SUBDIVISION REPORT - CONCEPT/DEVELOPMENT PLAN

► **FILE #:** 8-SG-26-C

► **SUBDIVISION:** 0 MARYVILLE PIKE

► **PROPOSED USE:** Multi-dwelling development

KEY SHEET / TYPICAL SECTION
0 MARYVILLE PIKE
 SITE ADDRESS: 0 MARYVILLE PIKE (37920)

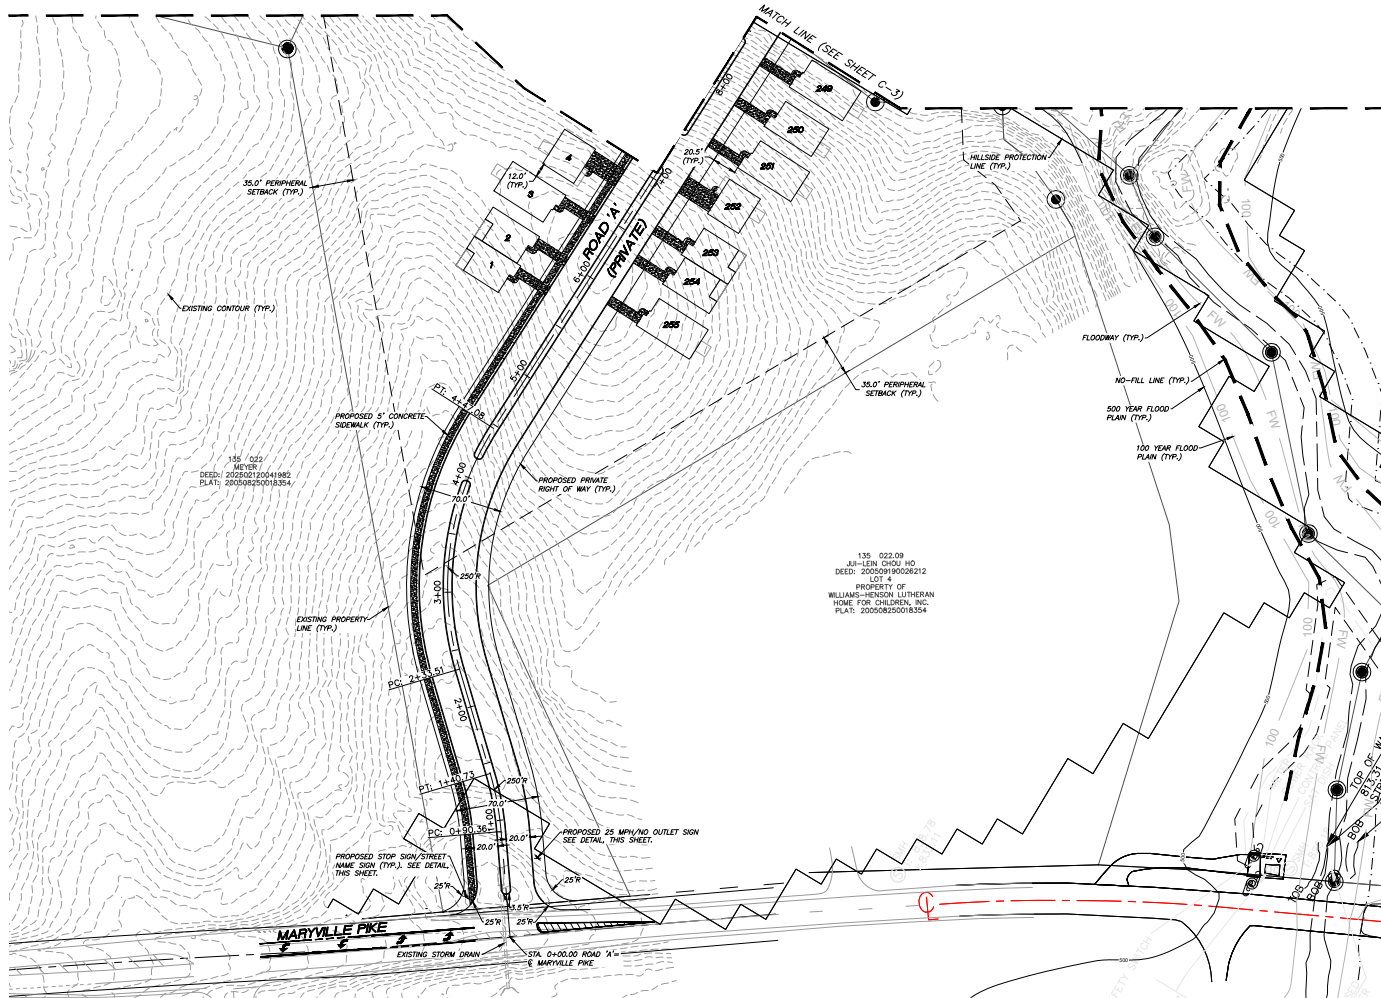
A. The property is in the SR (Suburban Residential) place type and is within the HP (Hillside Protection) and SP (Stream Protection) areas on the Future Land Use Map. The housing mix consists of attached residential uses such as duplexes, multiplexes, and townhomes that have the scale of a single family home. This plan will have 255 units of townhomes, duplexes, and single family style homes all on one lot. Building elevations have not been provided. A typical unit detail has been provided on sheet C-1. The units are similar to single family units.

PRELIMINARY GRADING PLAN
0 MARYVILLE PIKE
SITE ADDRESS: 0 MARYVILLE PIKE (37920)

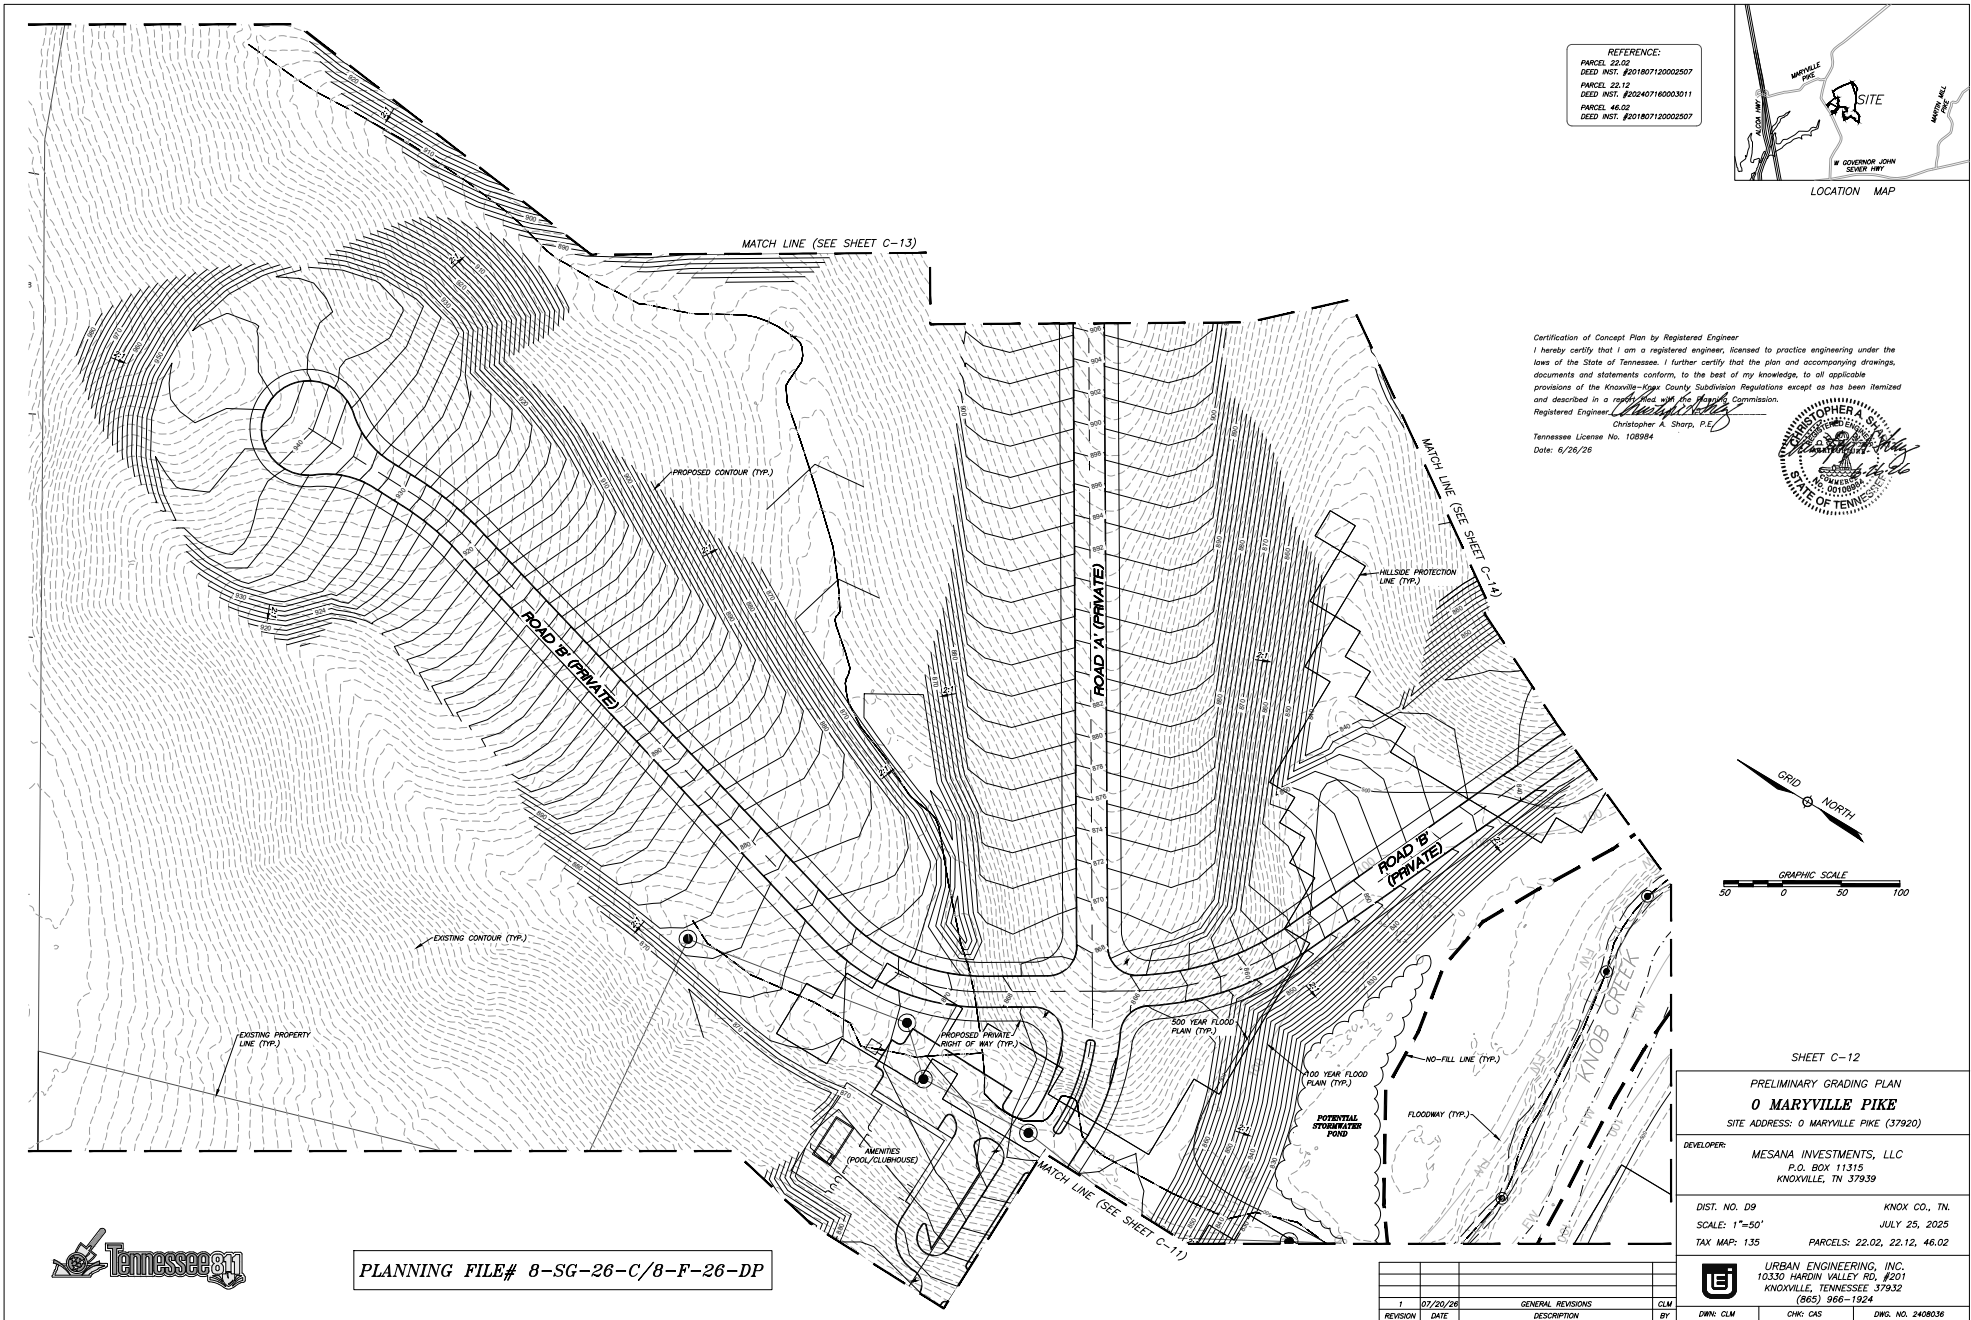
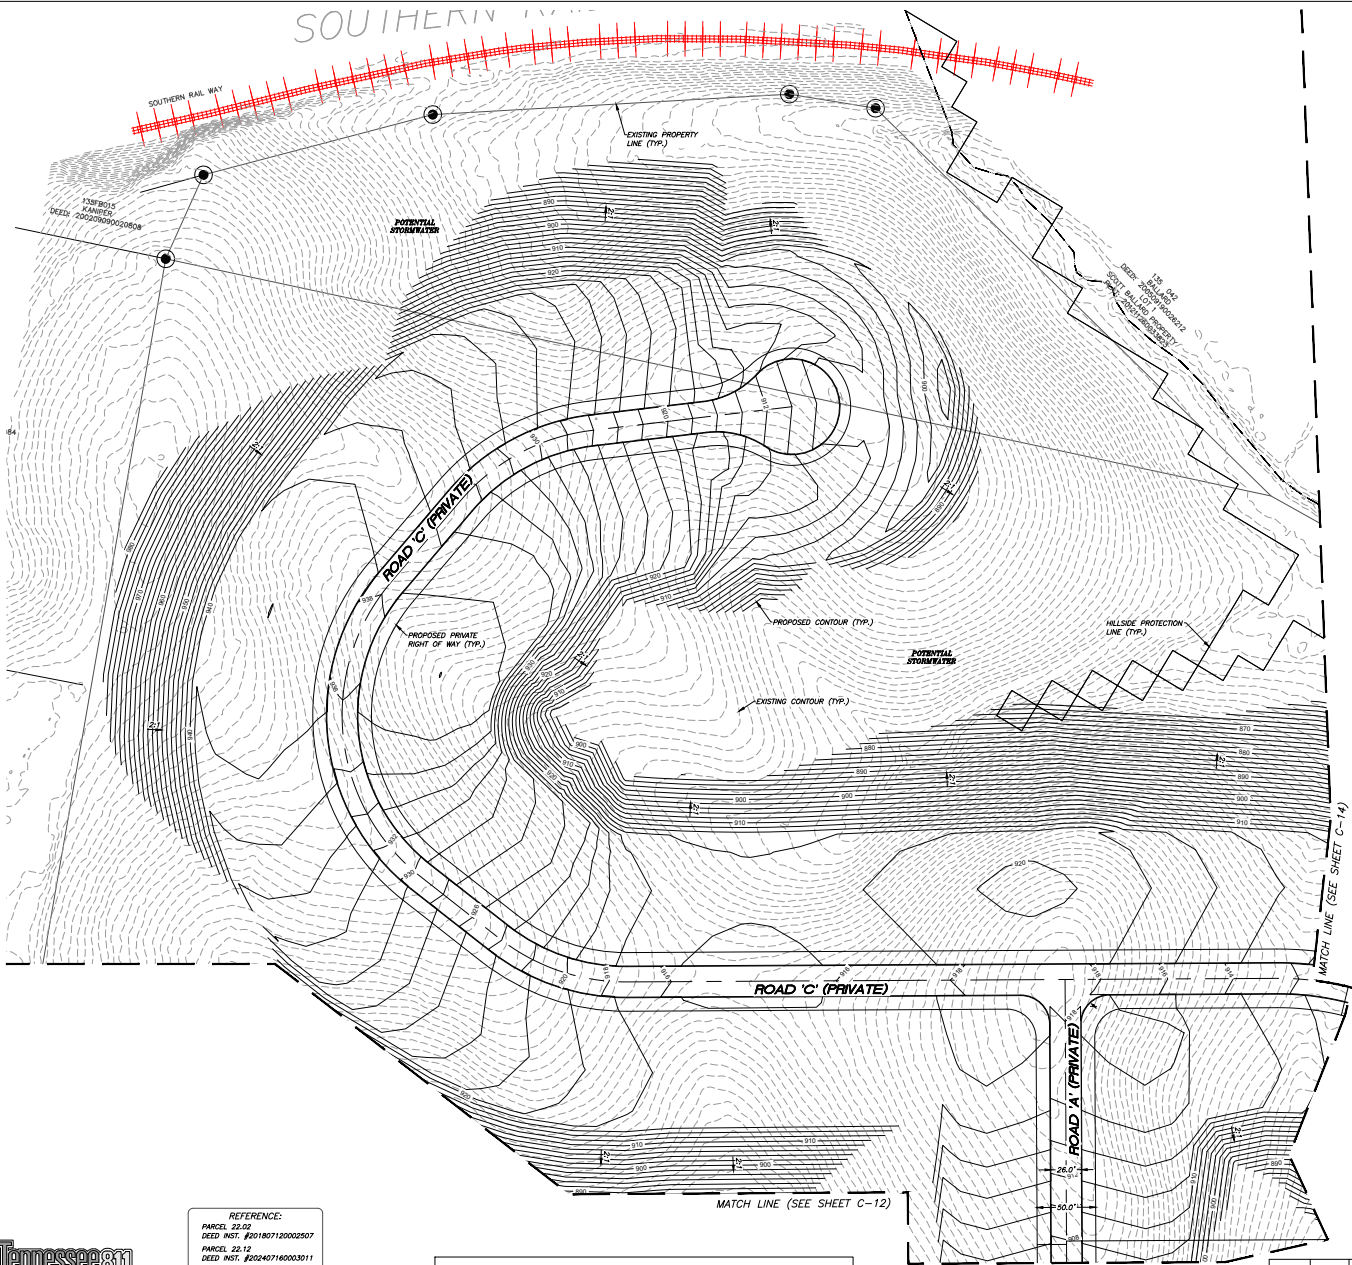
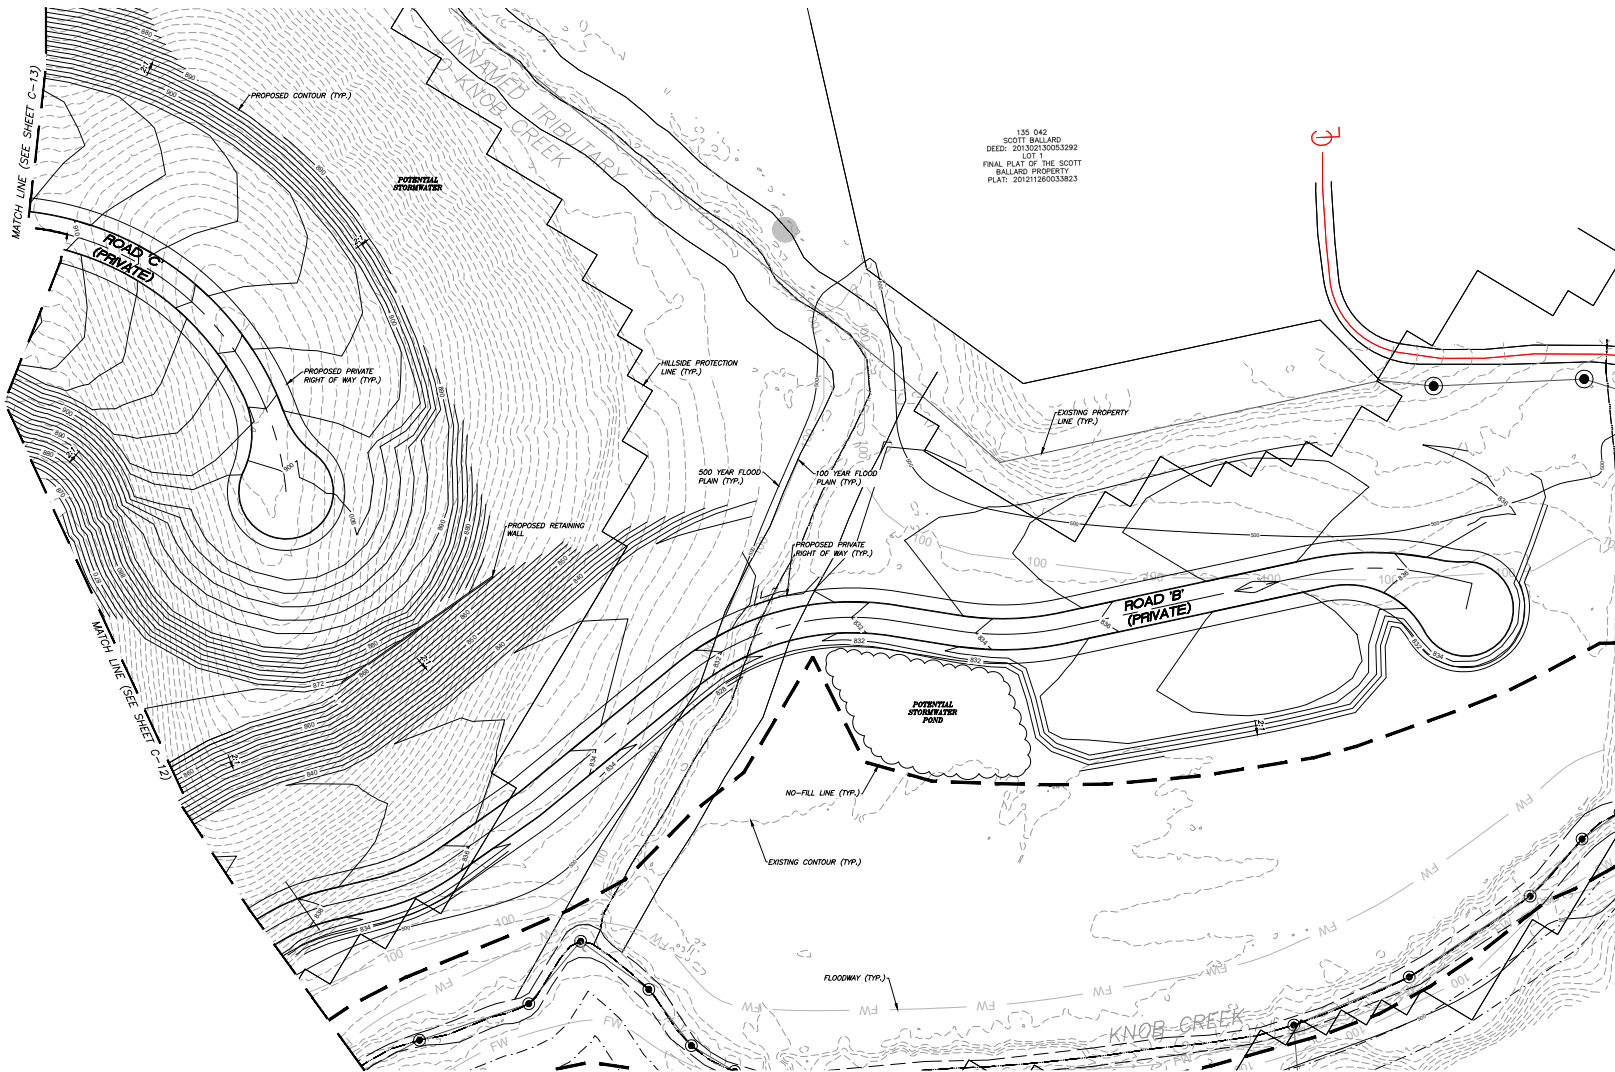
B. The grading plan remains unchanged from the previous approval. The recommended land disturbance budget is 37 percent (21.37 acres) of the HP area (see attached slope analysis). The proposed land disturbance in the HP area exceeds that recommendation by 65 percent (37.4 acres), which is 76 percent (16 acres) over the recommended disturbance area. There is a condition to reforest slopes or reduce the grading to comply with the slope analysis.

1. Meeting all applicable requirements of the Knox County Zoning Ordinance.
2. The maximum height will be 35 ft for attached houses.
3. Implementing reforestation of graded slopes and/or reducing the grading shown on the plan to comply with the recommended land disturbance of 21.37 acres, as shown in the slope analysis for the entire property. The Knox County Department of Engineering and Public Works will review and approve the timing for the tree
